Monticello Nuclear Generating Plant  
Docket No. 50-263  
Renewed Facility Operating License No. DPR-22

Part 2 Response to Probabilistic Risk Assessment (PRA) Related Requests for Additional Information: License Amendment Request for a Permanent Extension of the 10 CFR 50 Appendix J Containment Type A Test Interval (CAC No. MF7359)

**PART 2 RESPONSE TO PROBABILISTIC RISK ASSESSMENT (PRA) RELATED  
REQUESTS FOR ADDITIONAL INFORMATION**

## F RHR NPSH Limit (SPDS 74)

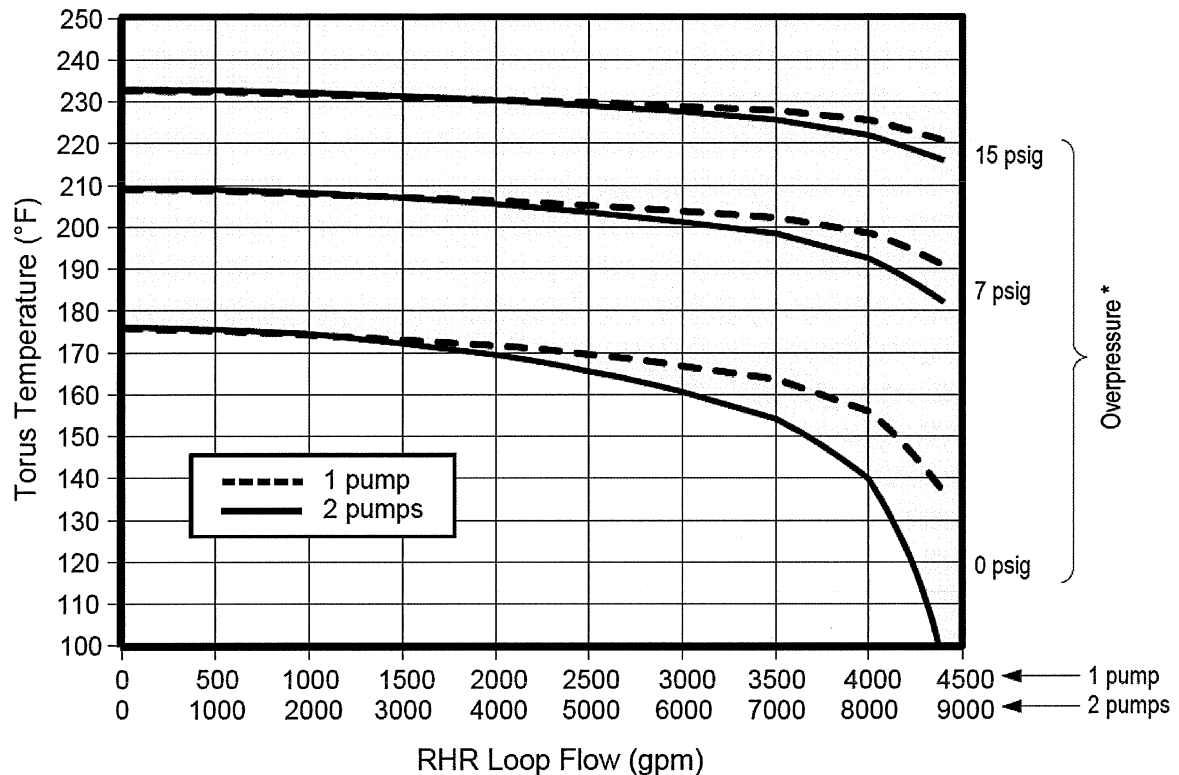
- c. **The LAR applies PRA credit for operator action to throttle low pressure ECCS flow. Describe the technical basis supporting ECCS throttling as a success criteria for containment conditions which defeat CAP for the PRA mission time. Describe which PRA sequences are credited and not credited.**

The use of CAP was reviewed extensively under the Extended Power Uprate (EPU) amendment and approved by the NRC. The MNGP Emergency Operating Procedures (EOPs) provide the primary and overriding direction for the use of ECCS pumps taking suction from the torus under emergency conditions. The EOP's include detailed guidance to operate these pumps in such a manner as to allow continued operation and yet preclude failure/damage to the pumps from inadequate NPSH. This guidance explicitly accounts for CAP or the lack thereof, as a function of pump flow and suppression pool temperature. The following figure is an example for the Residual Heat Removal (RHR) system taken directly from the EOP flowchart for Reactor Pressure Vessel (RPV) Control (C.5-1100), and is utilized by the operators to control pump flow such that NPSH limits are not exceeded.

Operators routinely and repetitively practice accommodating NPSH restrictions in the simulator control room under a wide array of accident conditions using the above figure.<sup>(7)</sup> This figure is duplicated in automated Safety Parameter Display System (SPDS) displays which plot the current plant conditions, thus allowing the reactor operators to easily assess the status of NPSH for the ECCS pumps that are in service and taking suction from the suppression pool.

For the purposes of responding to this RAI, as requested by the NRC, the PRA analysis was adjusted to remove credit for operator throttling of the low pressure ECCS pumps for any of the sequences.
